AUTOMATIC TRANSMISSION SERVICE GROUP

"VOLUME II"

INTRODUCTION

Since the introduction of the THM 440-T4 (4T60) Transaxle in April, 1984, there have been MANY major engineering design changes. These changes have affected nearly every part used in the THM 440-T4 (4T60).

Figure 1

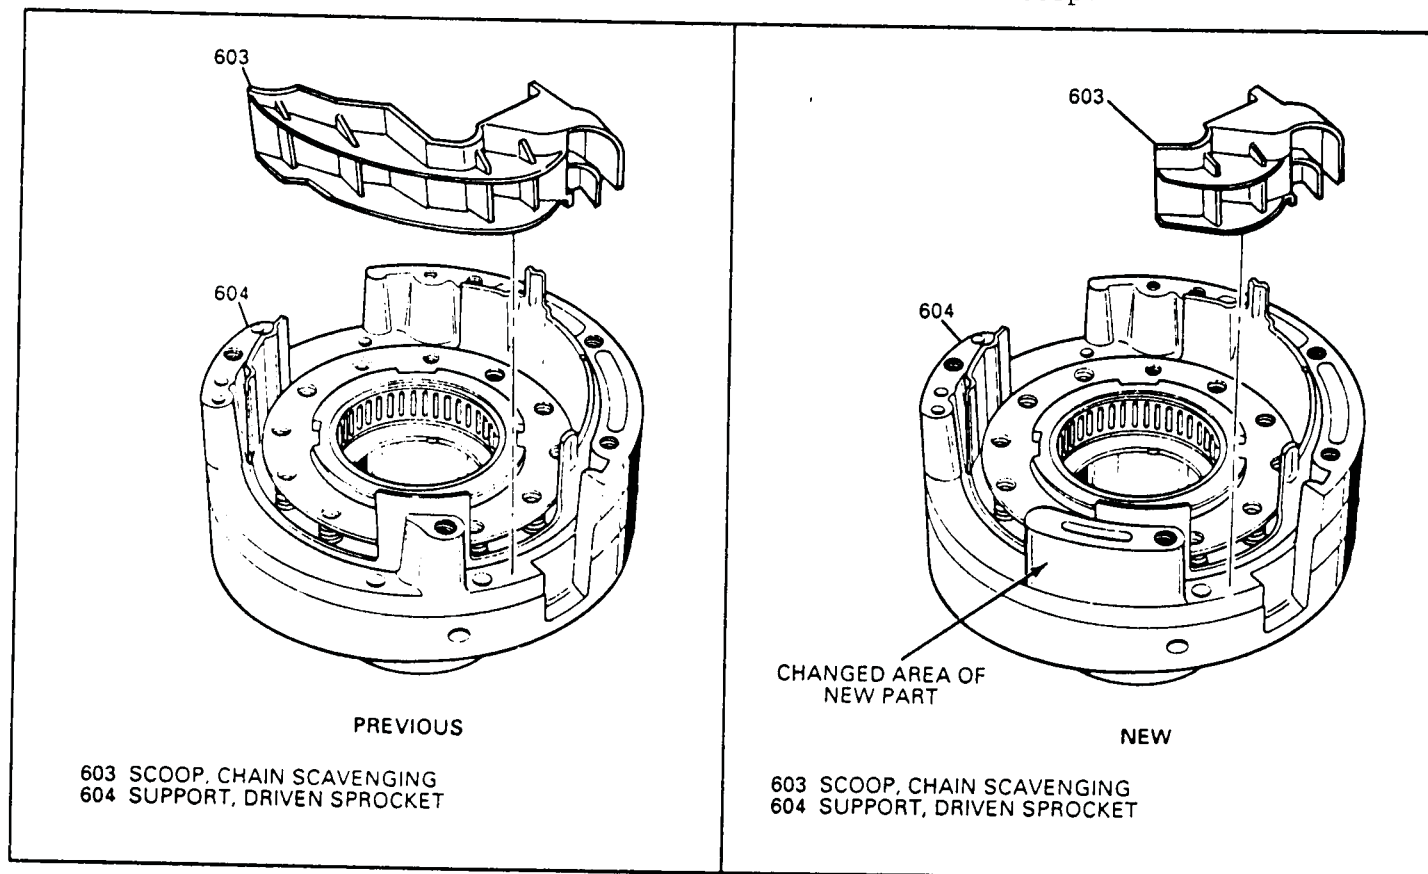
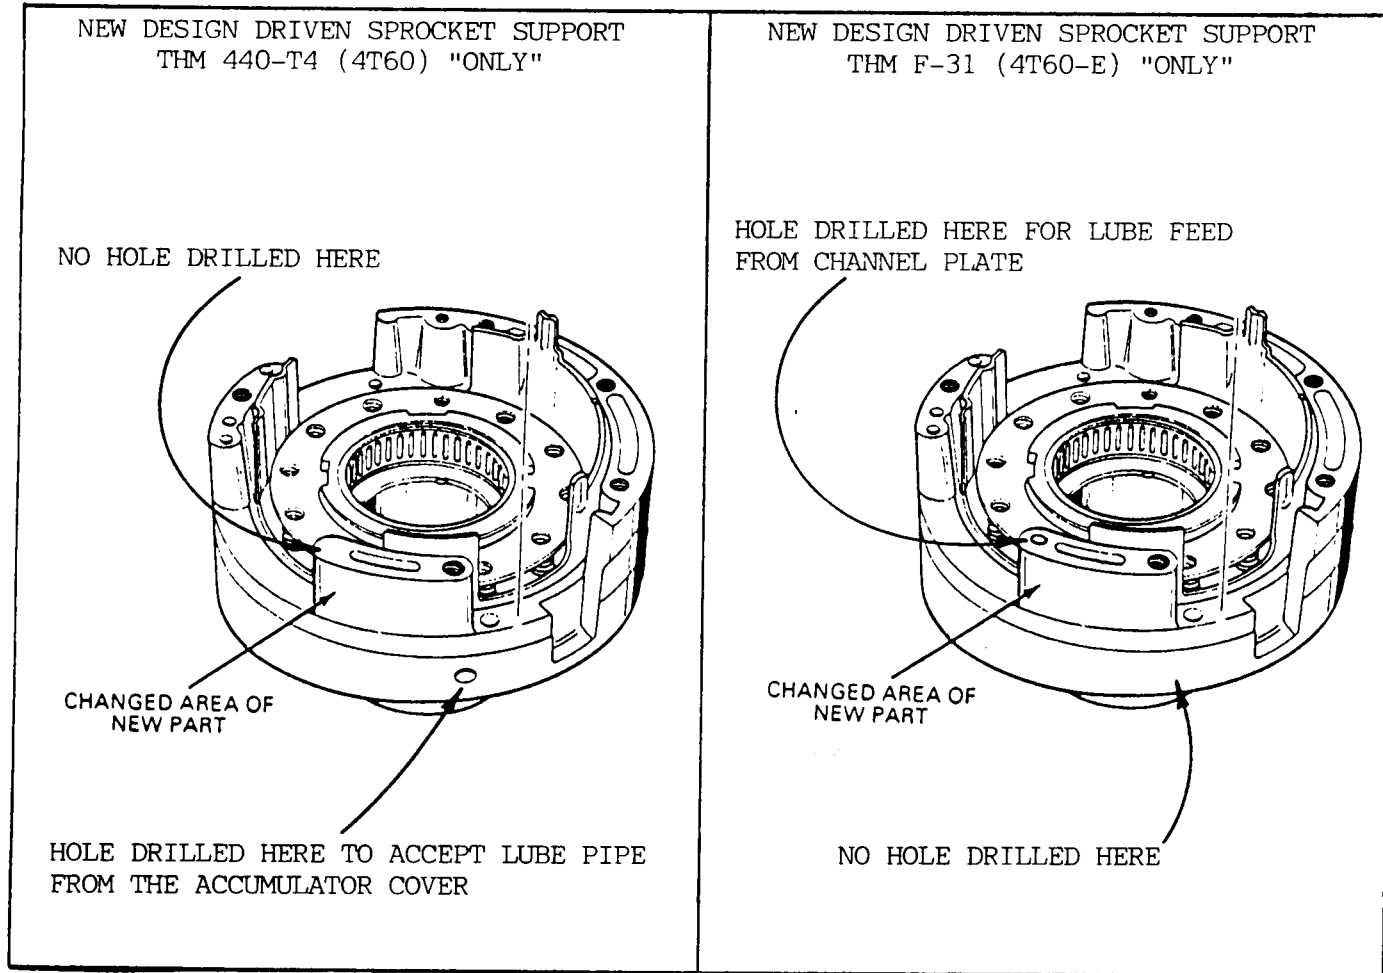
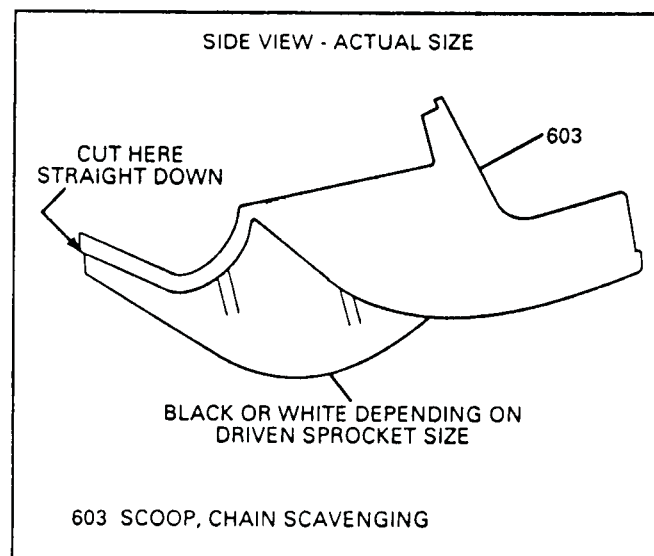
CHANGE: A new Driven Sprocket Support and Chain Scoop is now used in production on all 1990 vehicles equipped with a THM 440-T4 (4T60) transaxle. (See Figure 1).

- (1) **DRIVEN SPROCKET SUPPORT** - The new design sprocket support has an increased width of one leg on the support (See Figure 1). The wider leg on the new support will accomodate a new lube feed passage for the new THM F-31 (4T60-E) transaxle. Lube feed for the THM F-31 (4T60-E) will be thru the channel plate, instead of the pipe from the accumulator cover as on the THM 440-T4 (4T60) (See Figure 2).
- (2) **CHAIN SCOOP** - The new sprocket support requires the chain scoop, both black and white, to be about 1/3 the length of the previous chain scoop. (See Figure 1).

The new driven sprocket support will service all past models, but the new length (Short) chain scoop must be used with it. The previous (Long) chain scoop will not fit, but can be cut to fit the new support. Lay the previous chain scoop on the actual size drawing in Figure 3 and cut straight down, as indicated, with a hack saw. Smooth off the rough cut edge with sandpaper. The new length (Short) chain scoop must be used ONLY with the new design driven sprocket support.

Figure 4

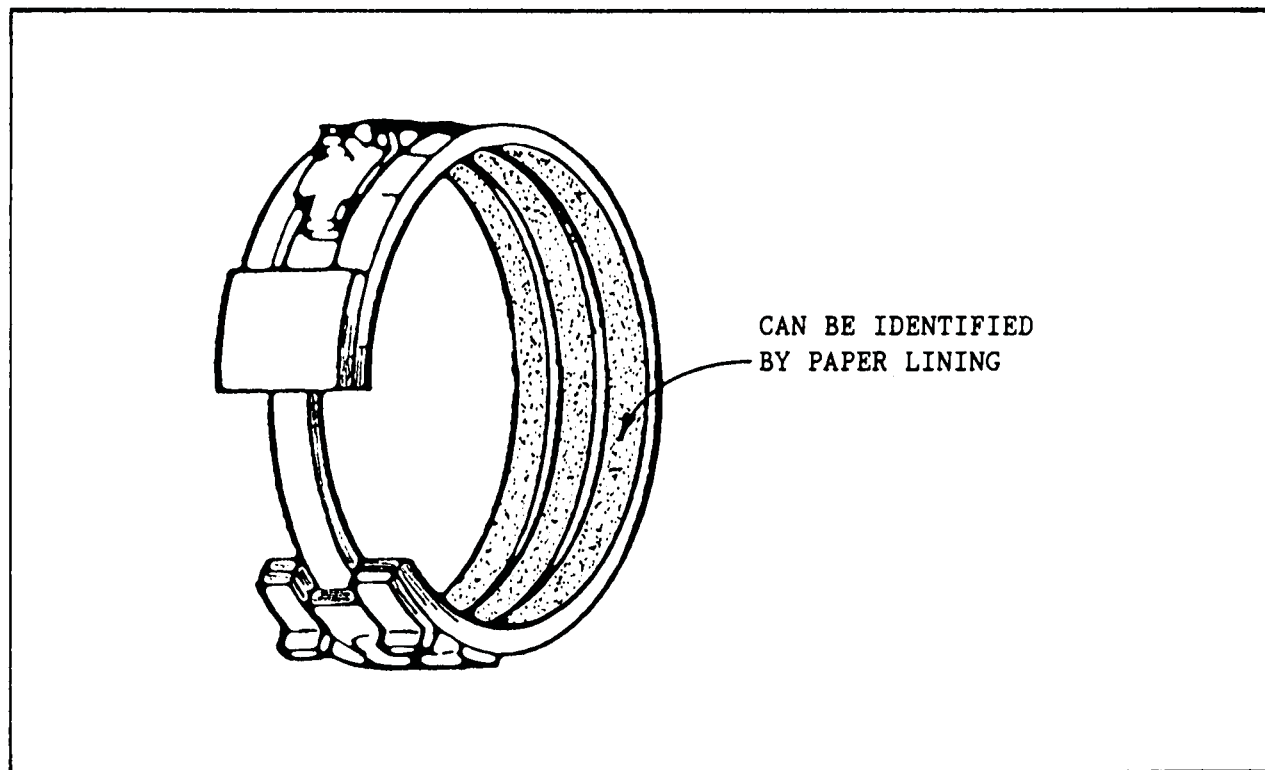
CHANGE: A 4th design Reverse Band Assembly is now in production on all THM 440-T4 transaxles.

- (1) REVERSE BAND ASSEMBLY - The lining on the reverse band has once again been changed, and can be identified by the "Paper" lining on the band itself (See Figure 4).

Figure 5

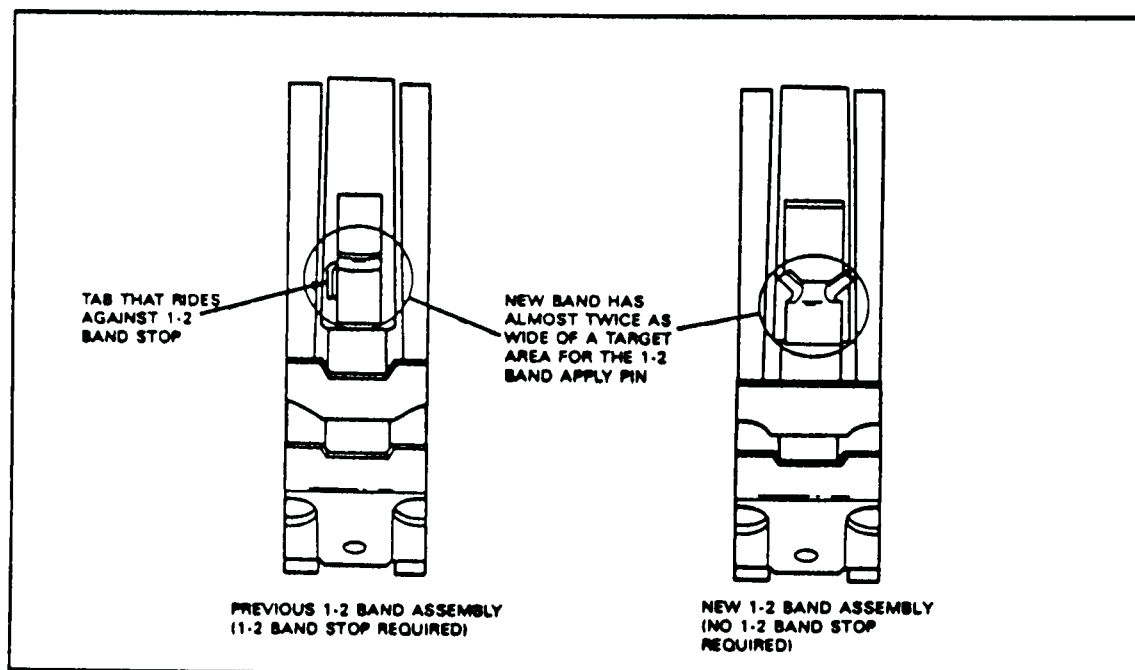
- (1) 1-2 BAND ASSEMBLY - The target area on the new 1-2 band, where the band apply pin engages, has been made wider and has "Wings" added to prevent the pin from ever missing the "Target" area (See Figure 5).
- (2) 1-2 BAND STOP ASSEMBLY - The 1-2 Band Stop has been eliminated as it is no longer needed (See Figure 6).

Figure 6

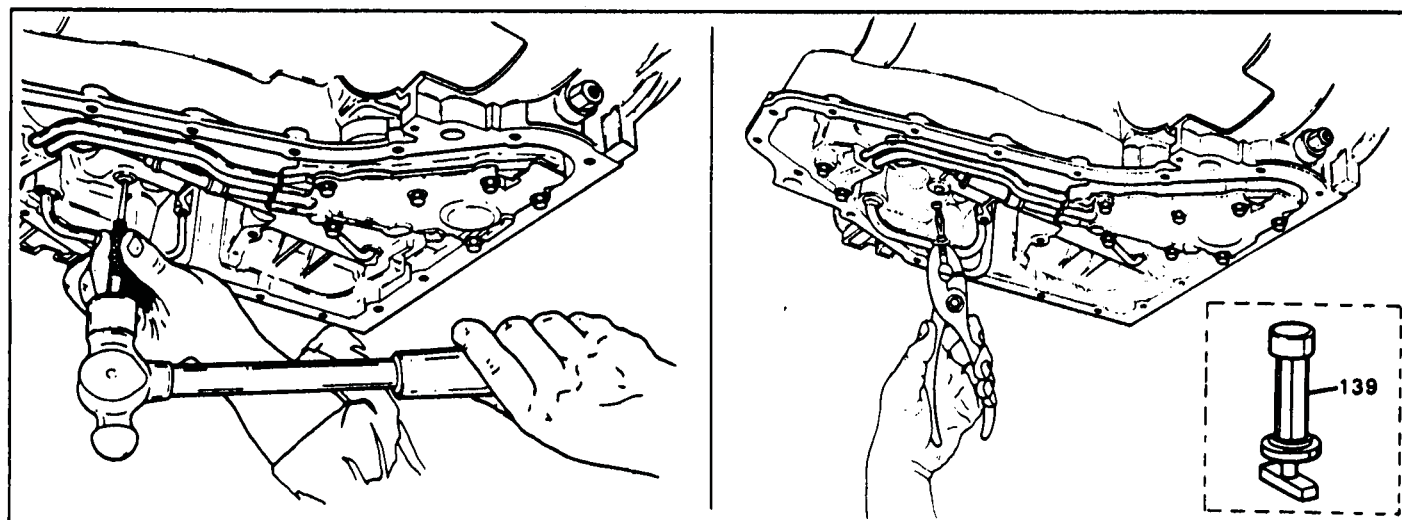
The new style 1-2 Band Assembly can be used to service ALL past models, but the 1-2 Band Stop MUST be removed and discarded (See Figure 6).

Figure 8

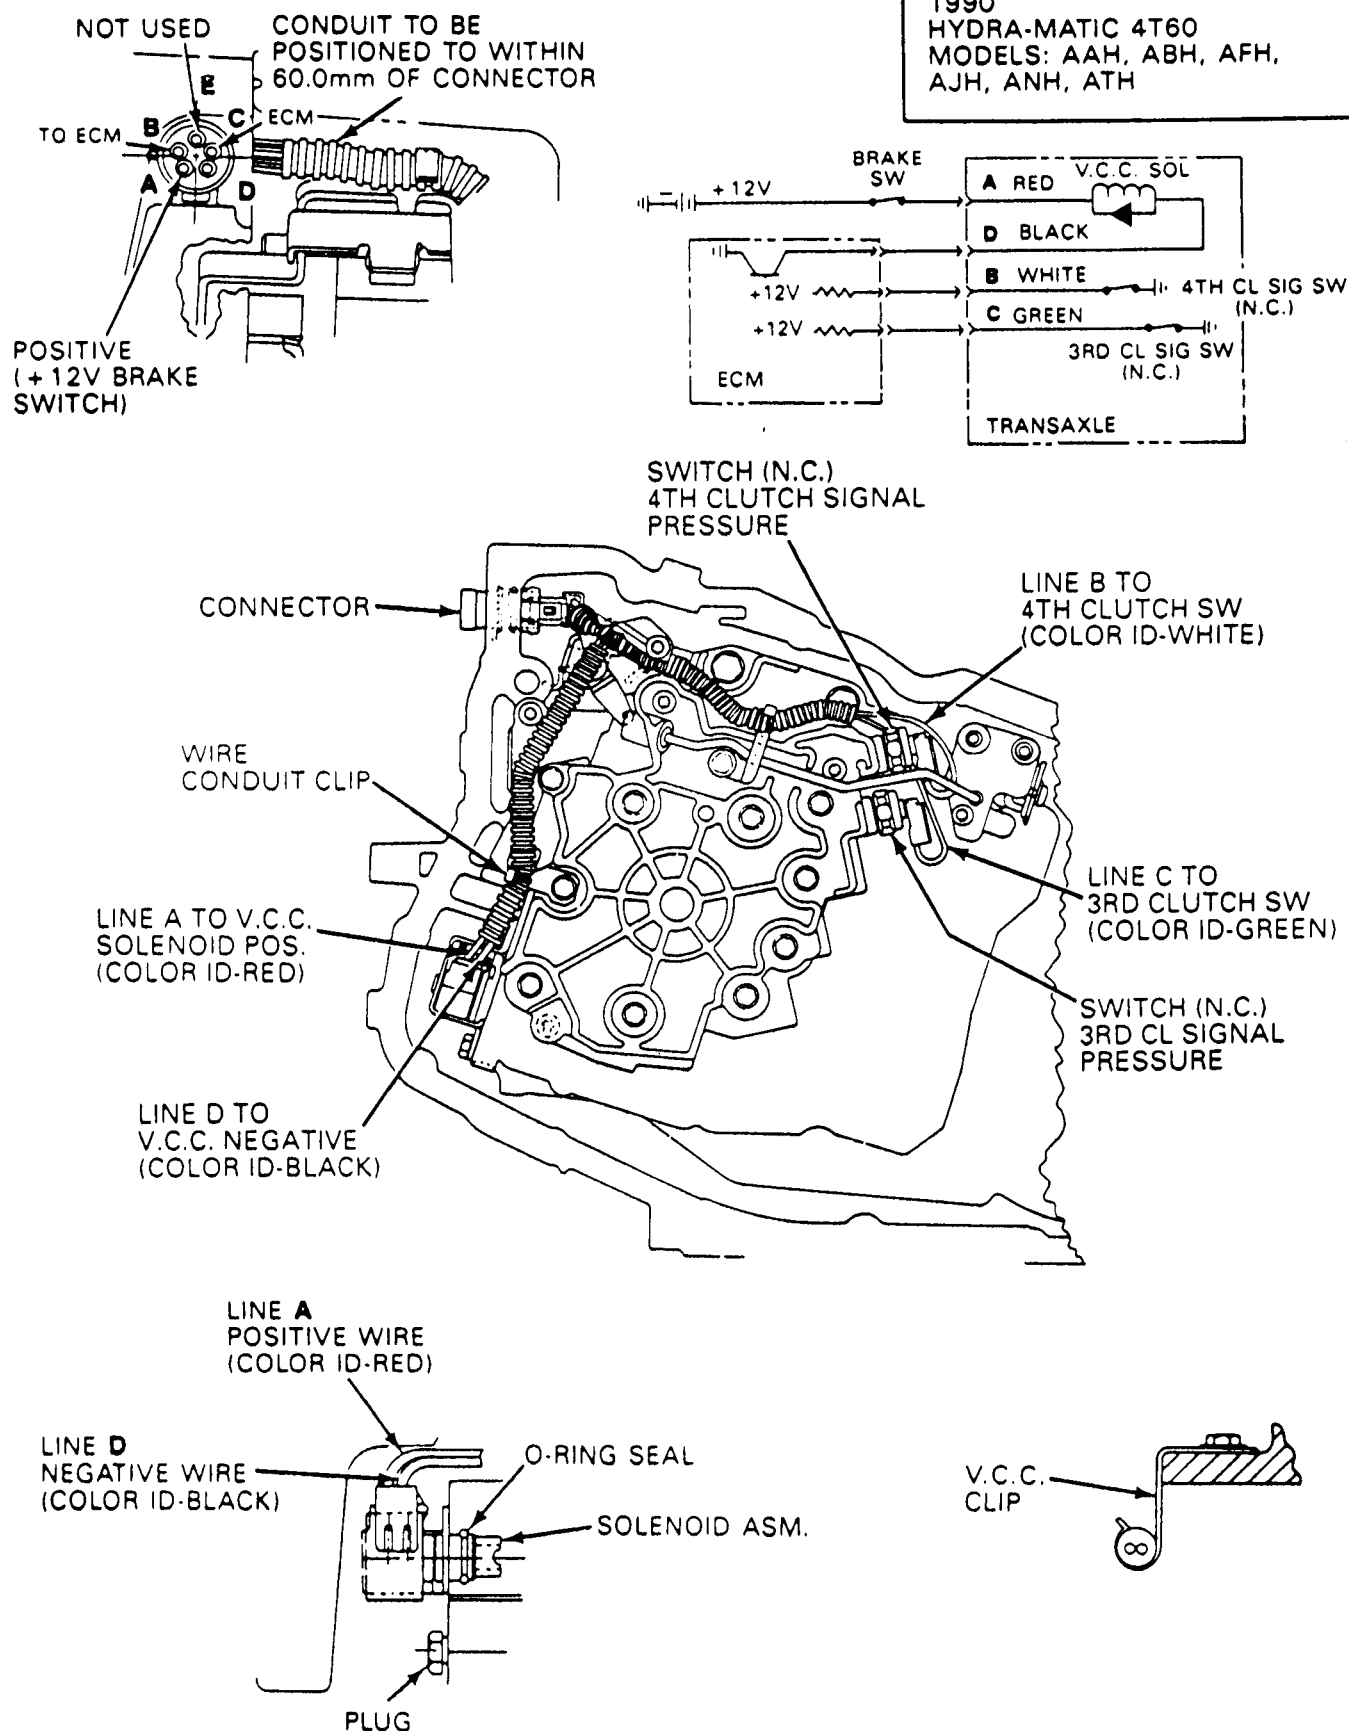
- (1) **PRESSURE SWITCHES** - The new 2nd, 3rd, and 4th clutch pressure switches will have "Button" head wire connectors instead of the "Blade" type connectors (See Figure 7).
- (2) **WIRING HARNESS** - The new wiring harness will have different type connectors to accomodate the new "Button" head switches. Refer to Figures 8, 9, & 10 for wiring harnesses.

Figure 11

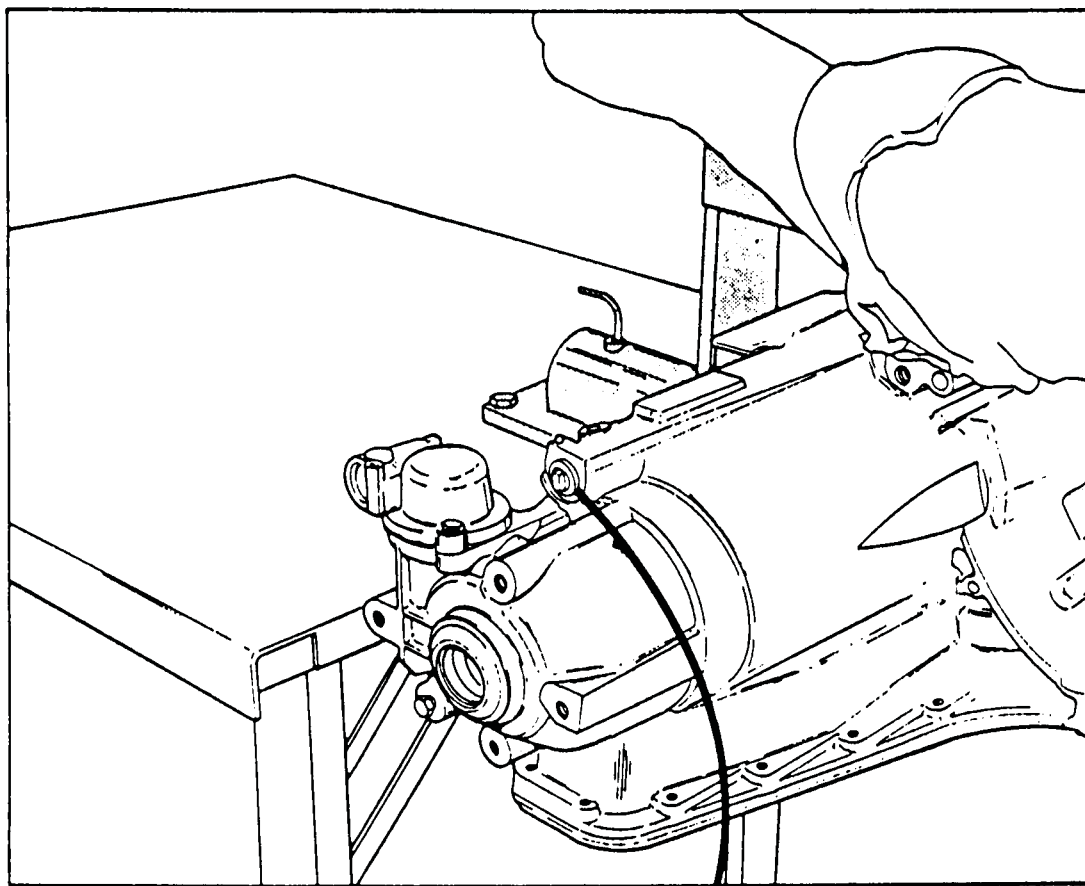
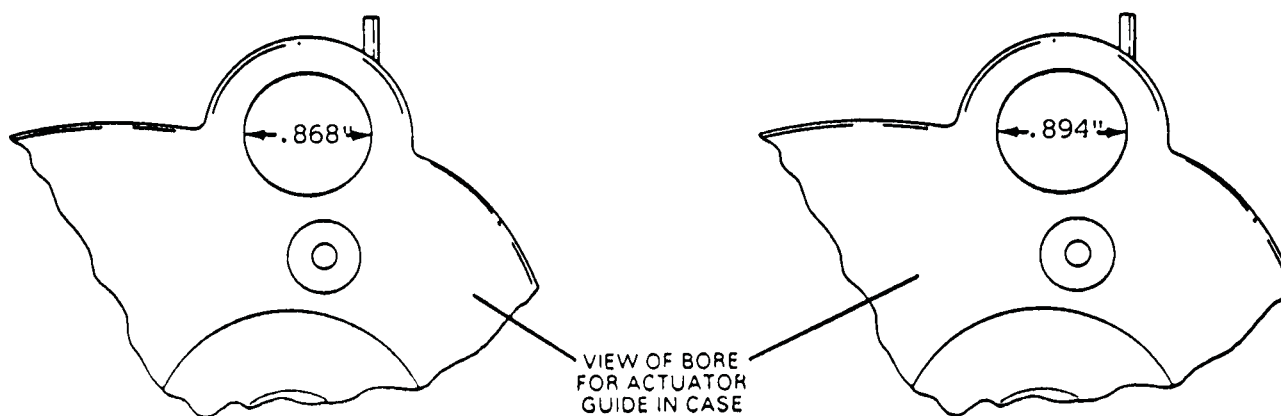
- (1) TRANSAXLE CASE - Bore diameter for the actuator guide has been increased by .026", to accomodate the new actuator guide (See Figure 11).
- (2) ACTUATOR GUIDE - Outside diameter has been increased by .026" for the increased diameter of the "Bullet" on the parking rod. The plunger assembly and spring have been eliminated. The slot in the actuator guide has been eliminated (See Figure 12).
- (3) ACTUATOR GUIDE "O" RING - The "O" ring is now larger diameter to seal larger diameter actuator guide (See Figure 12).
- (4) PARKING ACTUATOR ROD - The "Bullet" on the park rod is now .070" larger in diameter, and the length increased by .543" (See Figure 13).
- (5) PARKING PAWL - The parking pawl lock-out pin has been eliminated, and the dimension (Width) of the parking pawl was reduced by .039" (See Figure 14).
